Access Compliance Report

Public Rights-of-Way

(Curb Ramps)

Intersection ID: 3160	Main Street: BASKERVILLE_AV	Cross Street: CHISWELL_CT	Location: SE
ADA ID: CD0397837B7A	Ramp Type: Perp	Initial Pass/Fail: Fail	Overall Compliance: No
Severity Score: 12.5			
Codes/Mitigation Info/Possible Solution		Field Measurements/Component Compliance

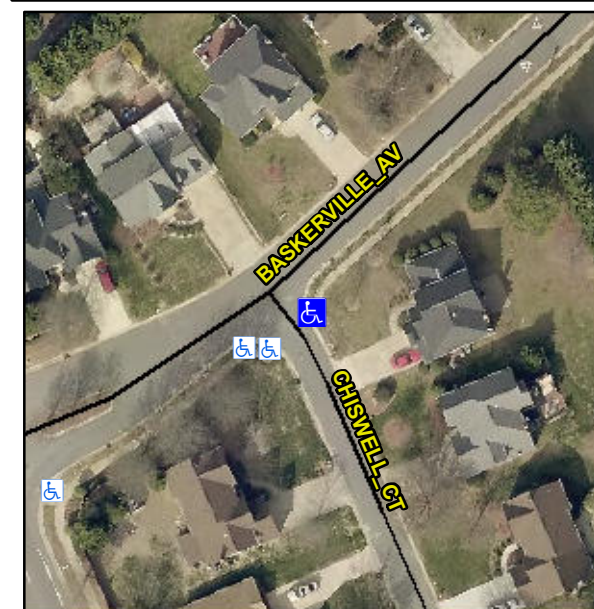
Not Found, R304.5.3

Compliance	Description	Data	Compliance	Description	Data
N/A	Ramp Length (in)	42.0	Yes	Ramp Slope (%)	5.1
Yes	Ramp Width (in)	58.0	No	Ramp XSlope (%)	5.1
N/A	Flare Type LT	N/A	N/A	Flare Type RT	N/A
N/A	Flare Slope LT (%)	N/A	N/A	Flare Slope RT (%)	N/A
N/A	Flare Traversable LT?	N/A	N/A	Flare Traversable RT?	N/A
N/A	Landing Length (in)	N/A	N/A	DWS Provided?	N/A
N/A	Landing Width (in)	N/A	N/A	DWS Contrast?	N/A
N/A	Landing Slope (%)	N/A	N/A	DWS Length (in)	N/A
N/A	Landing X Slope (%)	N/A	N/A	DWS Full Width?	N/A
N/A	Landing Curb? (Y/N)	N/A	N/A	DWS Offset (in)	N/A
N/A	Shared Landing?	N/A			
N/A	Gutter Ponding?	N/A	N/A	Gutter Slope (%)	N/A
N/A	Gutter Lip Ht (in)	N/A	N/A	Gutter X Slope (%)	N/A
N/A	Painted X Walk1?	No	N/A	Painted X Walk2?	N/A
	X Walk 1 Direction	To W		X Walk 2 Direction	N/A
N/A	X Walk 1 Width (in)	N/A	N/A	X Walk 2 Width (in)	N/A
	X Walk 1 Slope (%)	2.4		X Walk 2 Slope (%)	N/A
	X Walk 1 X Slope (%)	2.7		X Walk 2 X Slope (%)	N/A

Remove & Replace Entire Ramp.
